Re: License STC-133

**SUBJECT: Request for Additional Information Concerning
Application for Amendment to License Control Nos.
138087 and 138458**

RESPONSE TO COMMENTS
NRC/DNSC/ORISE/ORNL NOVEMBER 22, 2006
RAI FOLLOW-UP CONFERENCE CALL REGARDING
SITE-SPECIFIC DERIVED CONCENTRATION GUIDELINE LEVELS
FOR THE CURTIS BAY AND HAMMOND DEPOTS

Figure 2: Monitoring Well and Surface Water Sampling Locations (Radioactive Waste Site Monitoring Well Location is Shown in the 1999 Parsons Report Previously Provided)

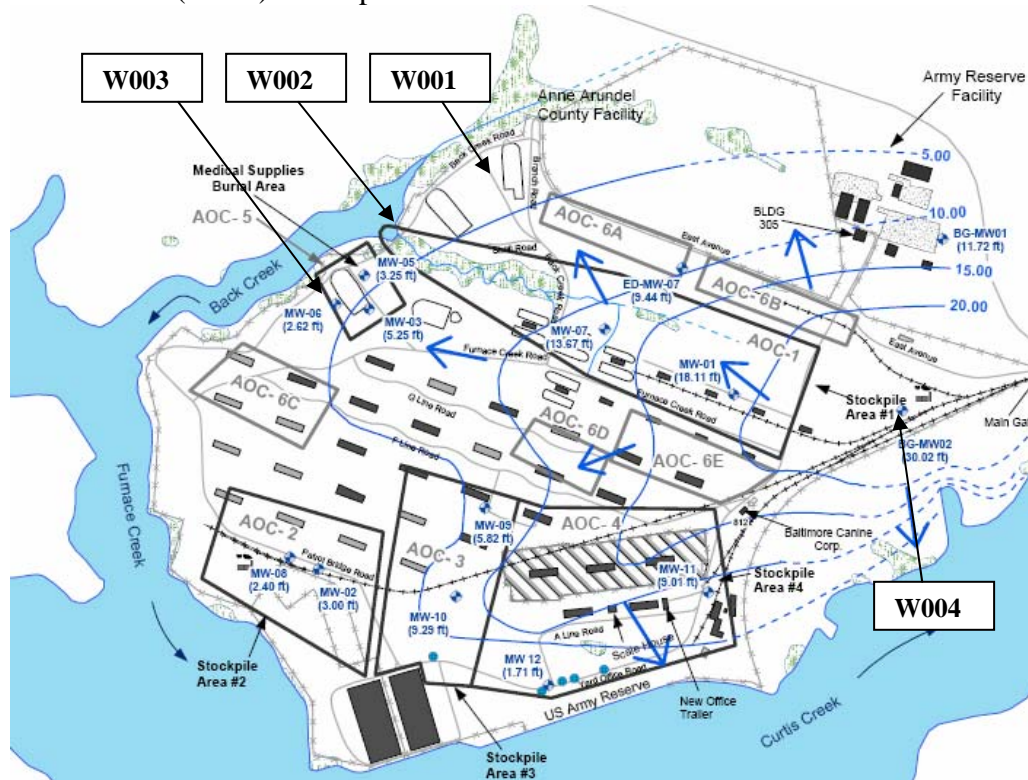
4. **Comment:** DLA should indicate a reference for background levels of Th in groundwater to support the statement in Curtis Bay RAI response 4 that the Th detects in groundwater near the radioactive waste disposal site are indicative of background contamination (groundwater data for Th are provided on page 3-14 of Parsons, 1999).

DLA should sample the groundwater well near the radioactive waste disposal site for radioisotopes of Th and U (depth to water and pH would also be useful information). DLA should provide any details regarding the groundwater well location (orientation with respect to the radioactive waste disposal site, groundwater flow direction, and expected surface water discharge points) and well screen depth in relation to the average water table elevation. DLA also indicated that it might take a surface water sample. The location should be just downgradient from the expected discharge point to surface water (e.g., along a reach of Furnace Creek).

DNCS Response: ORISE collected water samples from three groundwater wells and one surface water location on December 11, 2006. These wells included the monitoring well located within the boundaries of the former radiological waste disposal area (sample ID W001), one of the three monitoring wells (MW-06) installed to the southwest of the disposal area in the medical supplies burial area (sample ID W003), and one of the background monitoring wells (BG-MW02) installed on the eastern edge of the site (sample ID W004). A surface water sample was also collected from the small creek that flows into Back Creek (sample ID W002). Figure 2 shows monitoring wells and creeks (Parsons 2006). The monitoring well within the radiological waste disposal area is shown in the 1999 Parsons report (Parsons 1999). Samples were collected in accordance with ORISE procedures. The depth to the water table was recorded for each well

sampled. Each well was then purged an equivalent of three volumes prior to collecting the samples. The pH of each sample was determined in the ORISE laboratory prior to sample acidification and processing. Samples were analyzed by alpha spectroscopy for isotopic thorium and uranium. The results are provided in Table 1. All results were less than or equal to the minimum detectable concentration (MDC) of the procedure.
